Architect's Supplemental Instructions

PROJECT:
Summit Square
Apartments Phase II
 837 NW Donovan Road
 Lee's Summit, MO 64086

ARCHITECT'S SUPPLEMENTAL
INSTRUCTION NO.: 16

At the Owner's request, an addition to serve as the Parcel Storage room was added to Building 1. Additional revisions and clarifications to the scope are summarized per sheet, and reason for the change where applicable:

2 ELEVATOR SECTION BLDG D
SCALE: 1/4" = 1'-0"

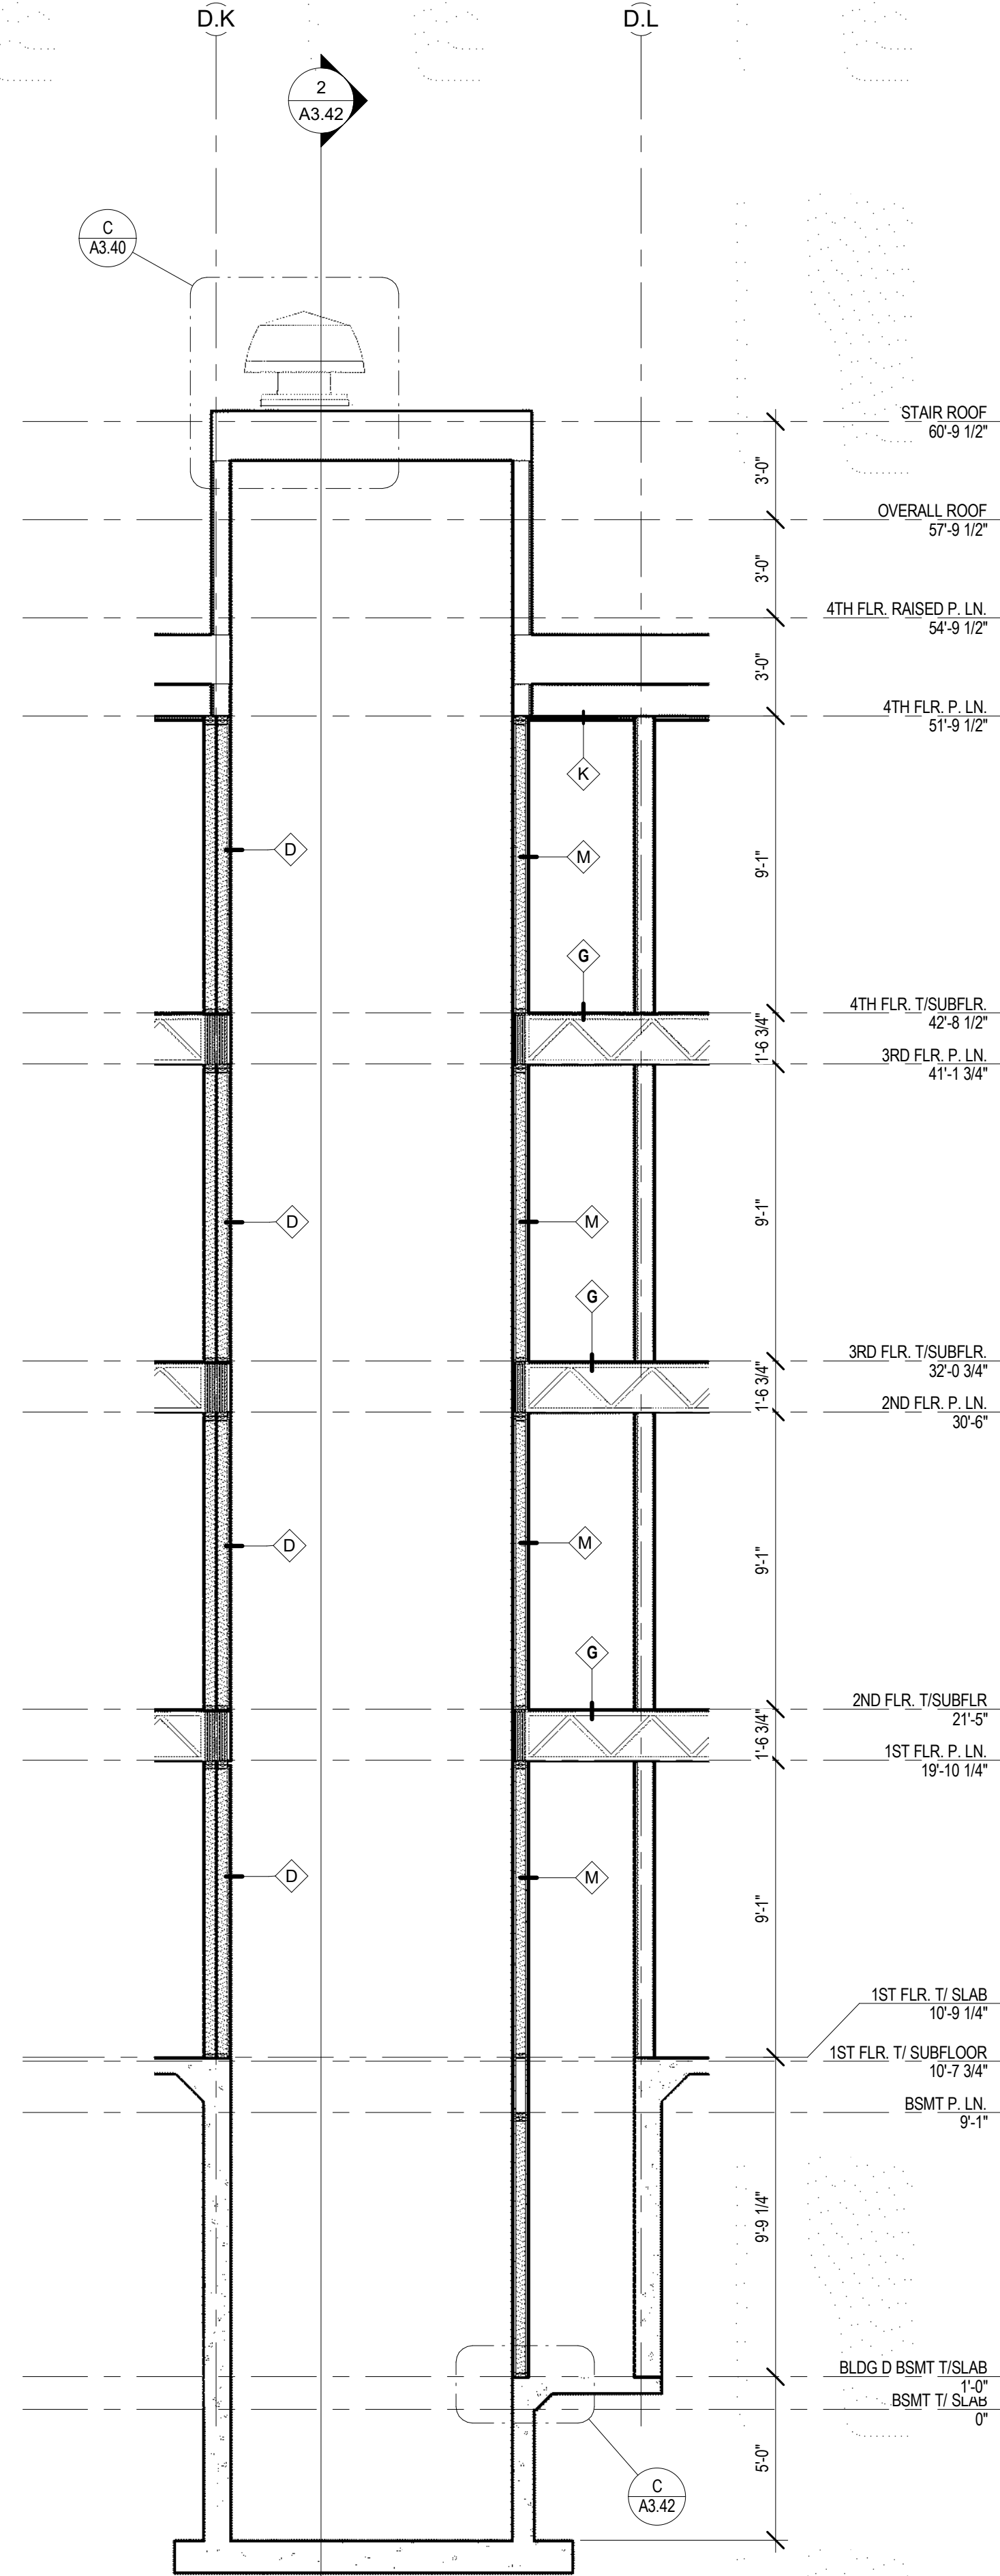
- A3.42 *Document Elevator Beam Height change (as indicated on Elevator Shop Dwgs)*
- A7.00 *Addition of Parcel Storage room, Removal of Yoga Storage Room and associated changes*

A7.01

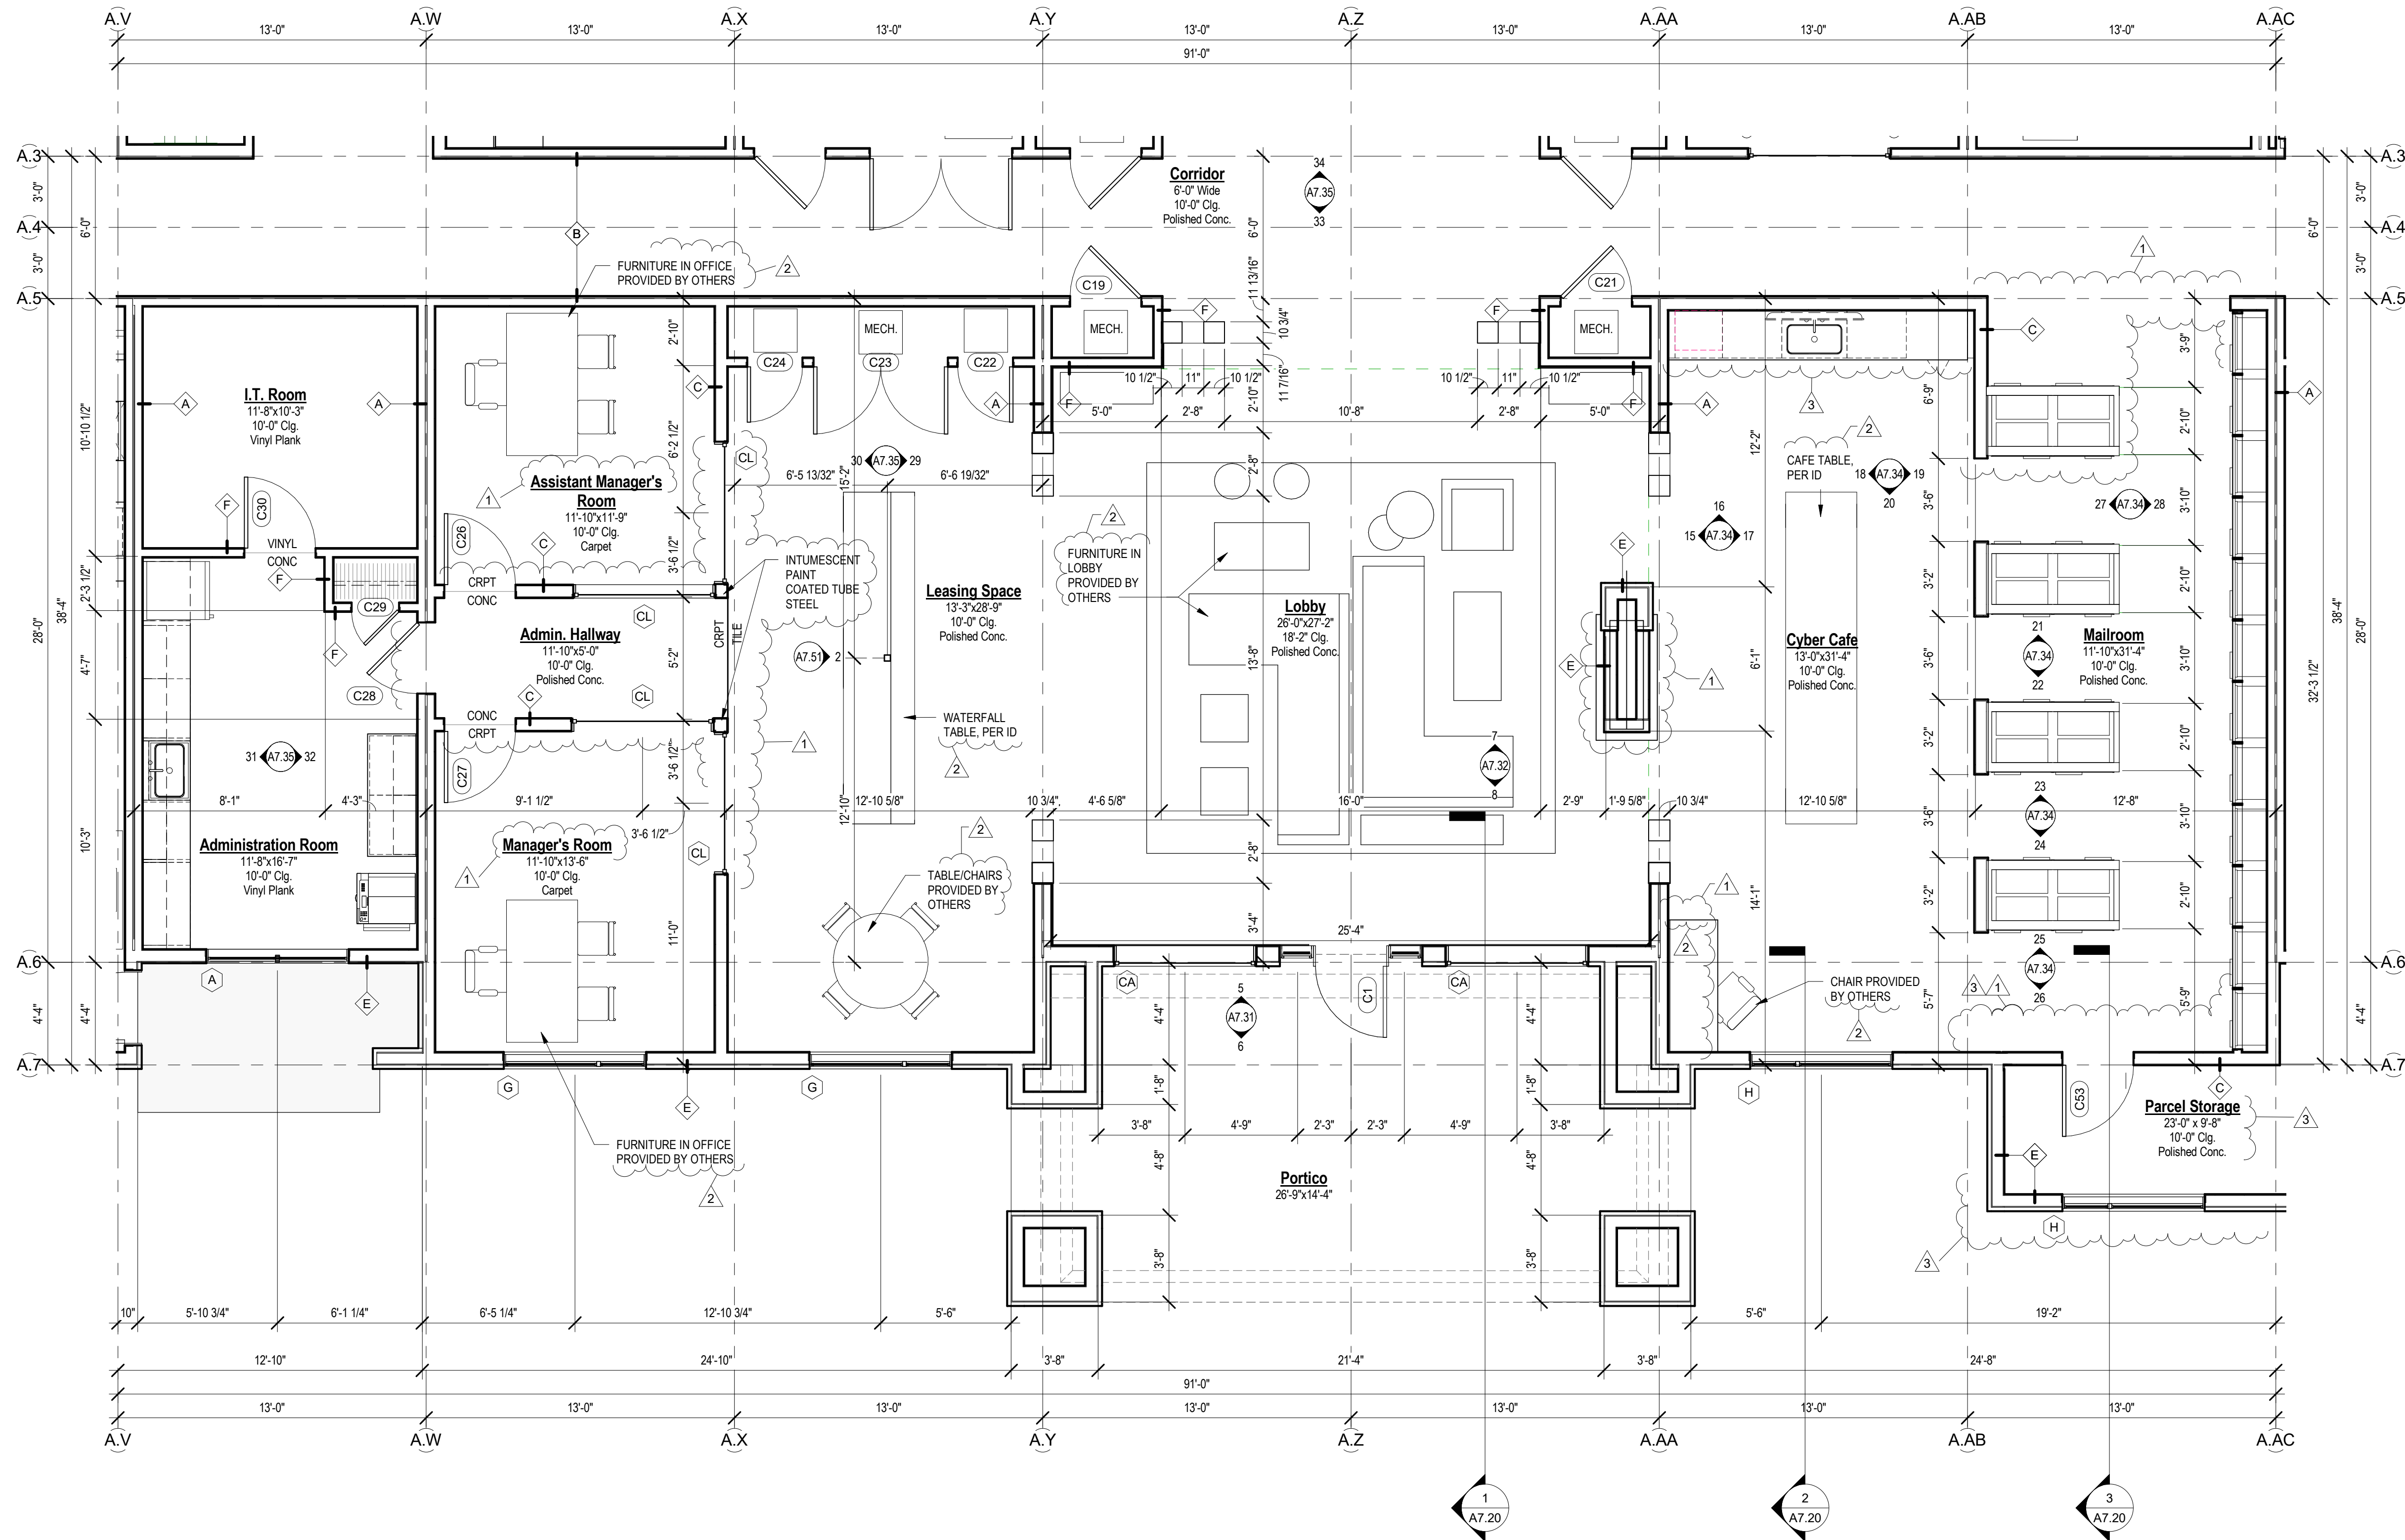
- A7.01 *Addition of Parcel Storage room and associated changes*
- A7.02 *Addition of Parcel Storage room and associated changes*
- A7.04 *Removal of Yoga Storage Room and associated changes*

S2.11B

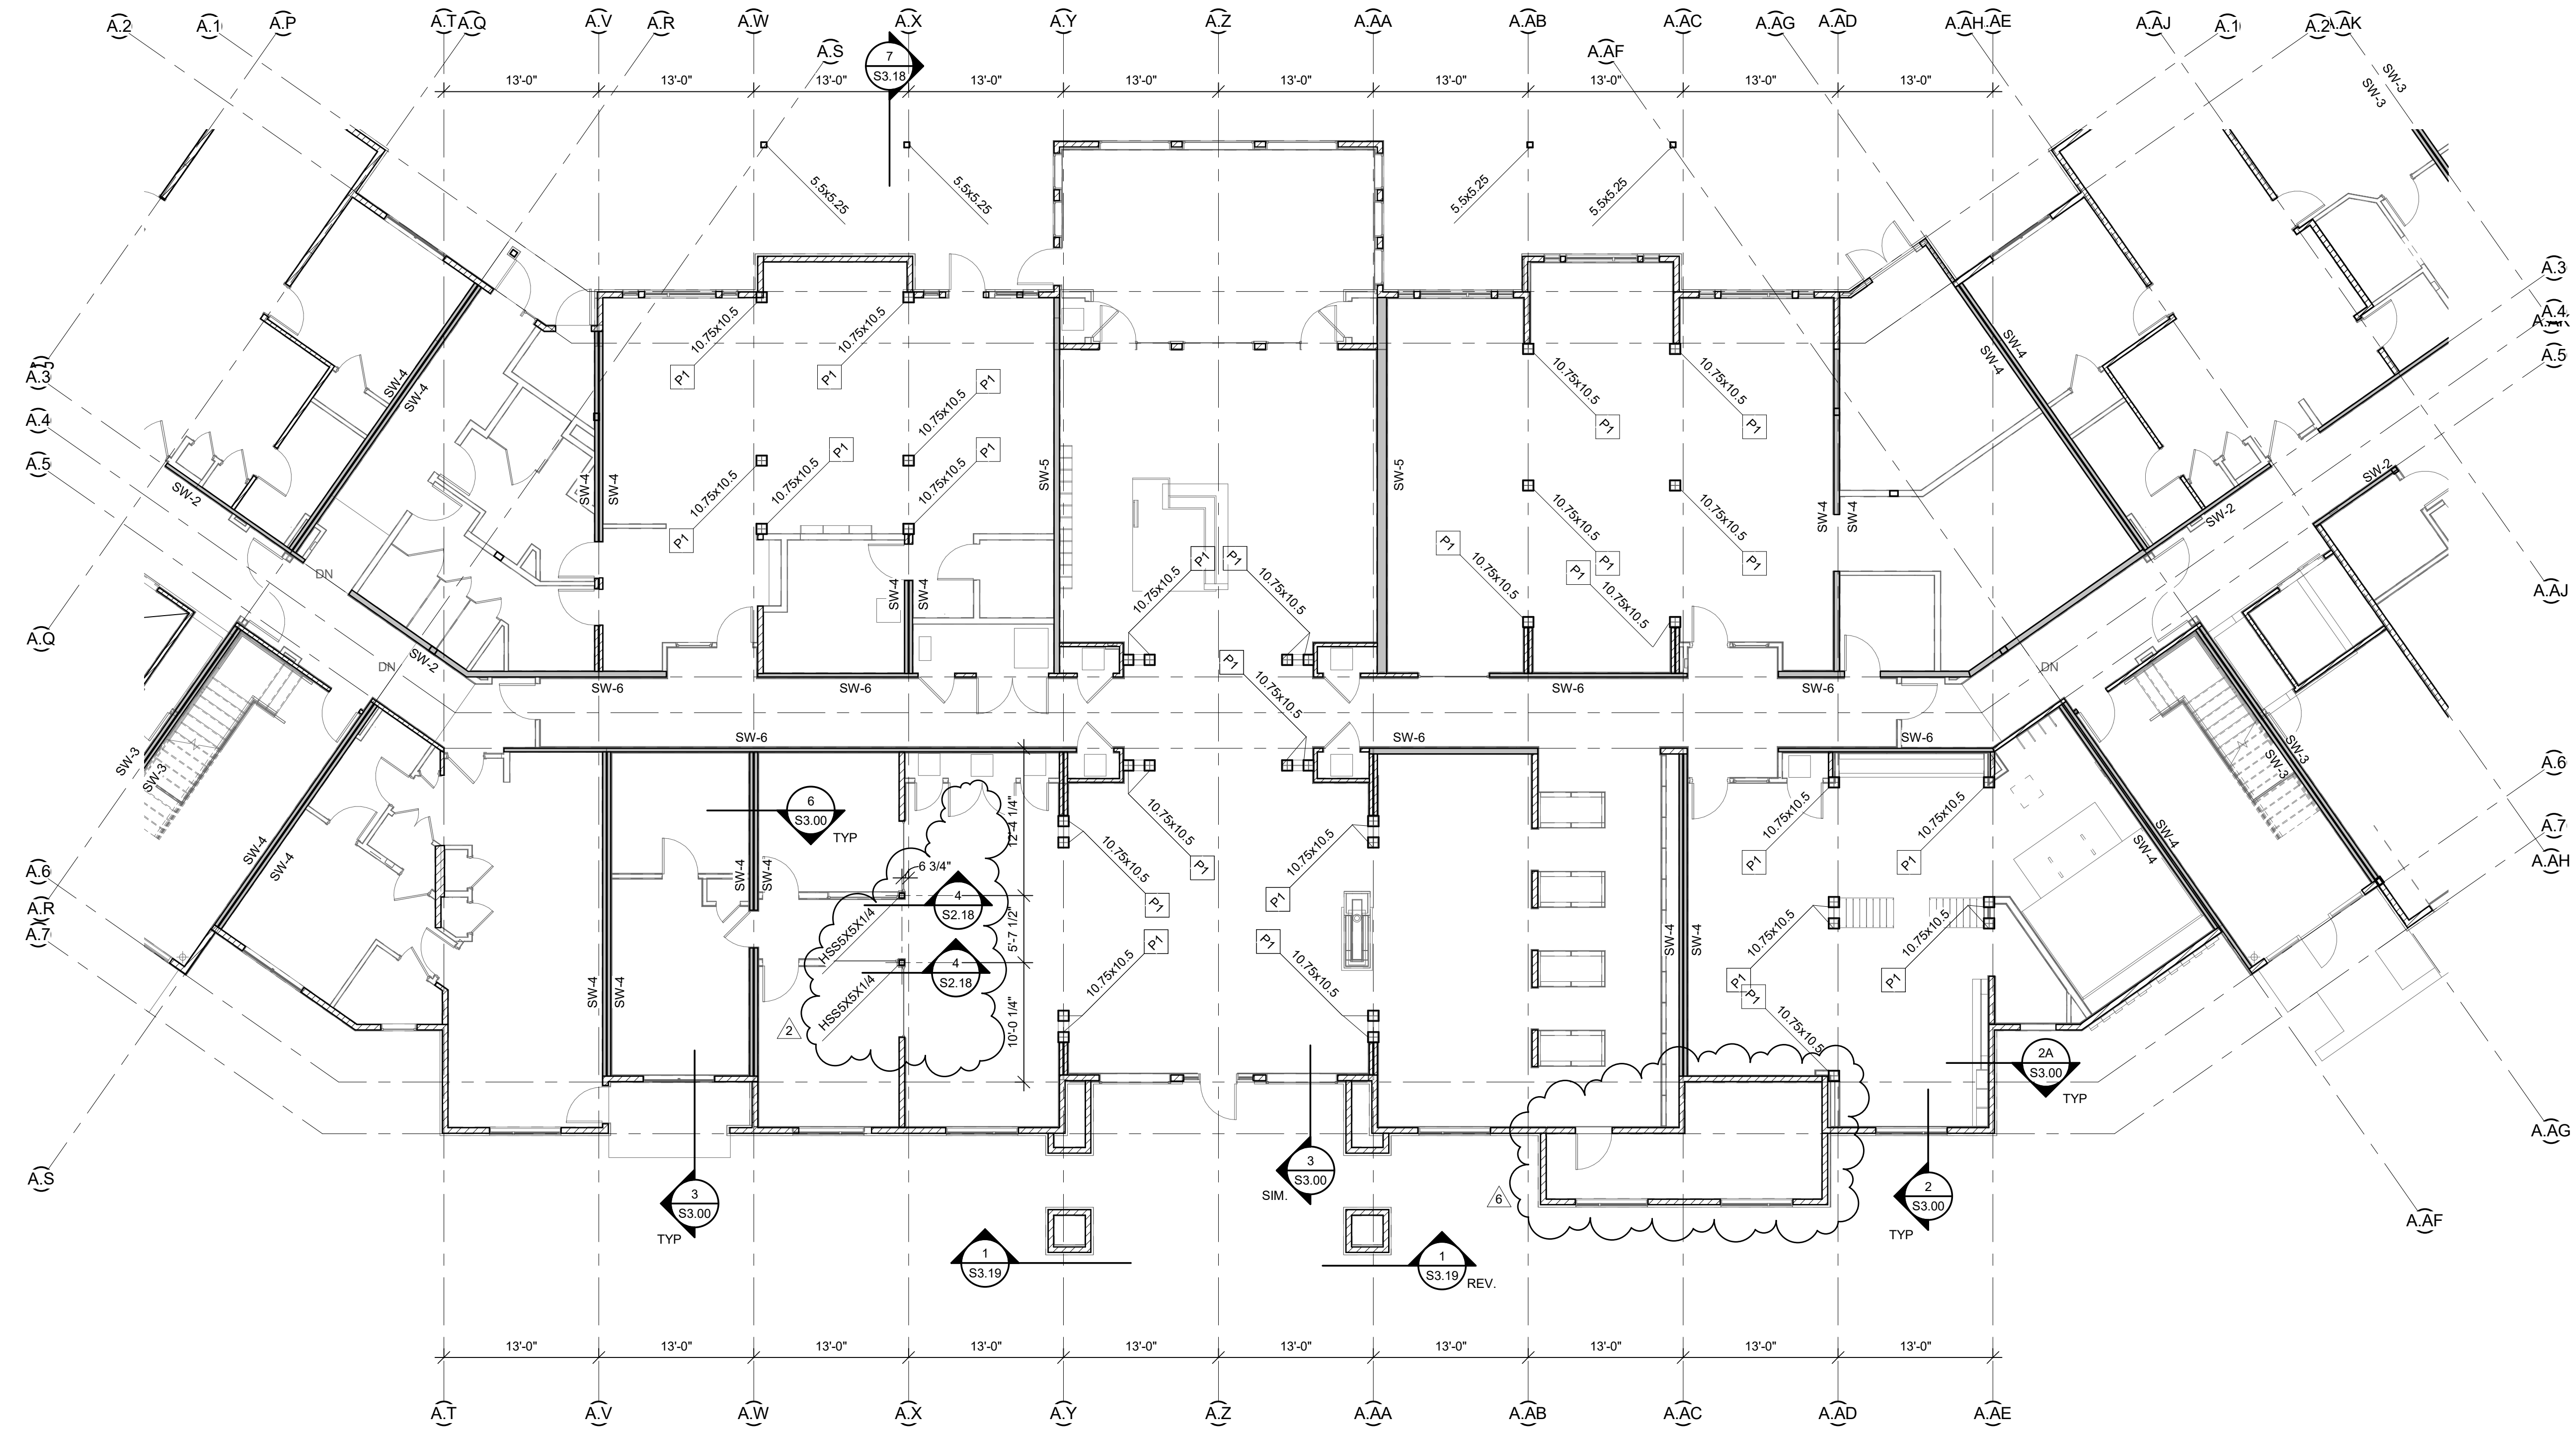
- S2.11B *Addition of Parcel Storage room and associated changes*
- S2.12B *Addition of Parcel Storage room and associated changes*
- S2.12C *Structural revisions (as previously indicated on TJI shop dwgs)*
